RE: Fair Haven Historic Preservation

Block 49, Lot 18 (39 DeNormandie Avenue)

Proposed Alteration, Renovation, Addition

PROPOSED PROJECT FOR THE

FRONT ELEVATION SCALE: 1/4" = 1'-0"

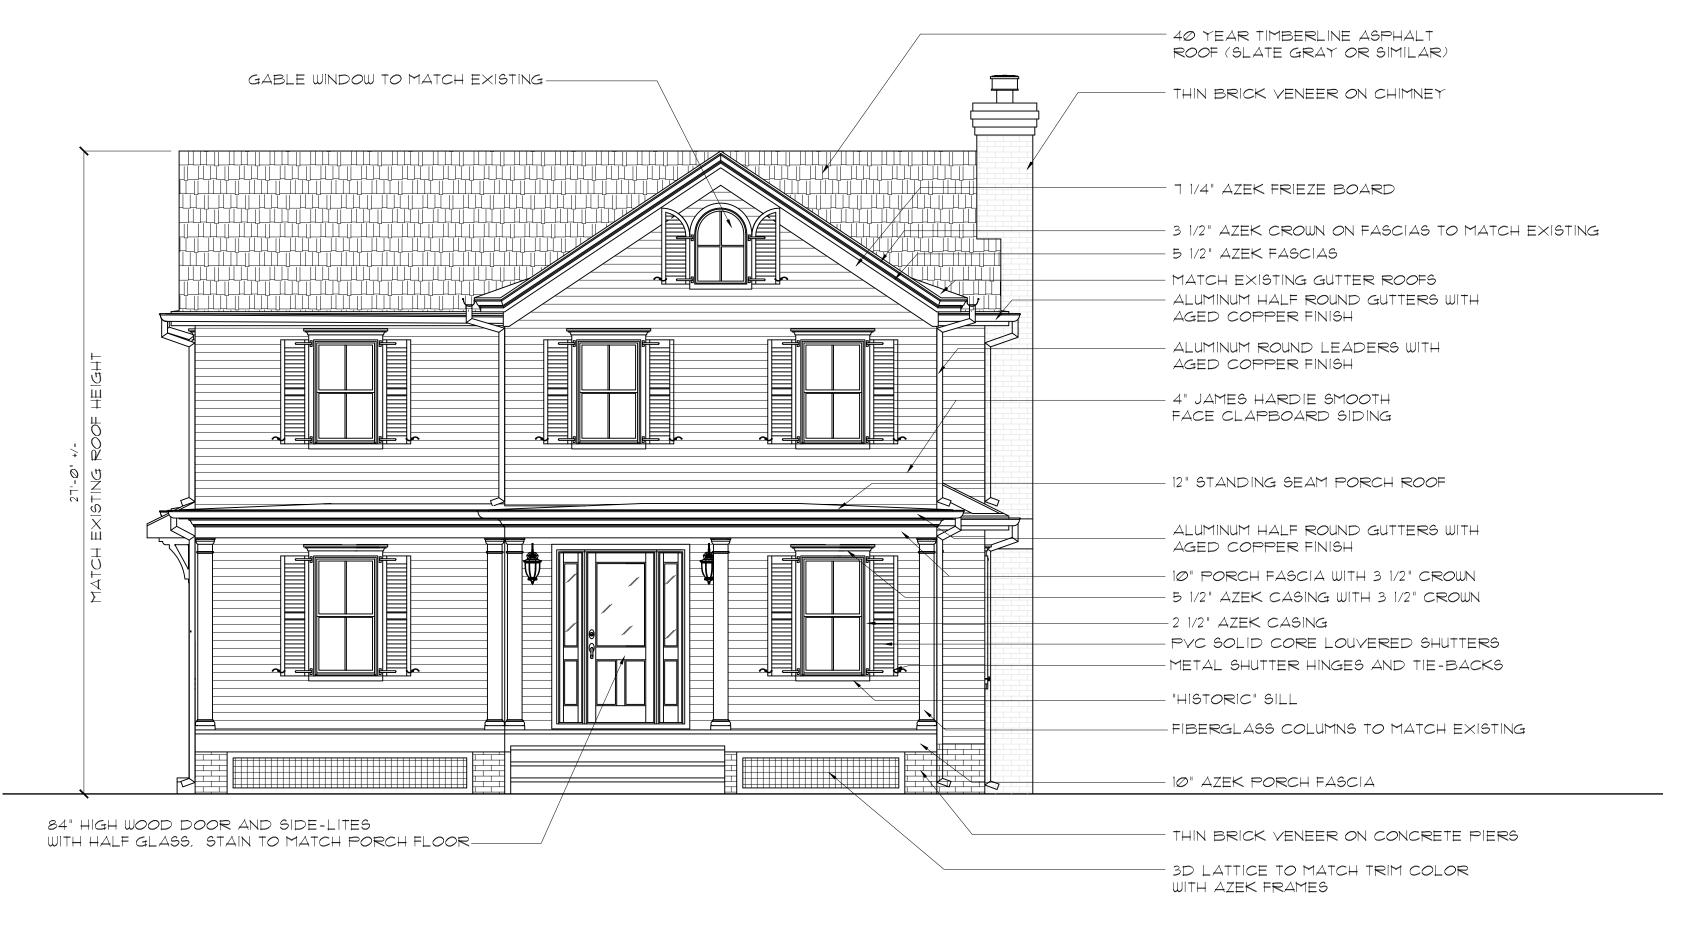
- 1. Elevation drawings could incorporate specification of corner boards, which have not yet been indicated. Quarter round beaded detailing (where corner boards meet) are optional, but would bring an added historic element, often found on dwellings of that era.

- 2. Specification and detailing of windows with historic sills in lieu of casing sill aprons at all double hung windows.
- 3. Specification and detailing of all exterior window and door casing at the exterior to be with 5/4 inch material, and the head trim to extend beyond the vertical casing by 1/2 inch at each side, especially at the rear and side elevations where no shutters are proposed.

- 4. Historically, windows of this era were tall and narrow. Window sill height at the first floor tended to be closer to the finished floor at an average of 18 inches while the second floor windows were incrementally shorter than the first floor windows. Some window proportions could be revisited when drawings progress into the construction document phase. Code requirement for egress windows, however, must be maintained where new construction is proposed.

- 5. The architect has already indicated for operating metal hardware at all window shutters which is an admirable addition.
- 6. The upper half or two-thirds of the front door should to be glazed, regardless of the addition of complementary sidelights or transom.

- 7. Lastly, consideration should be given to the type of roof drainage system to be installed. It may have already be considered but is undiscernible from the reduced scale elevation drawings. A half round gutter system, with exposed hangers set at 24 inches on center, is recommended when restoring or reconstruction historic structures, where box gutters are not present. Downspouts should also be cylindrical to complement the suggested period style gutter.

The positioning of the door, whether it be to the side center or as shown in the most recent set of plans available to our office, is somewhat inconsequential. Given the proposed addition to the side... the best option appears for a front entry door to be closer to the center of the front elevation, as depicted by the Architect of Record. A door positioned between the addition and original dwelling's front provides a better balance.
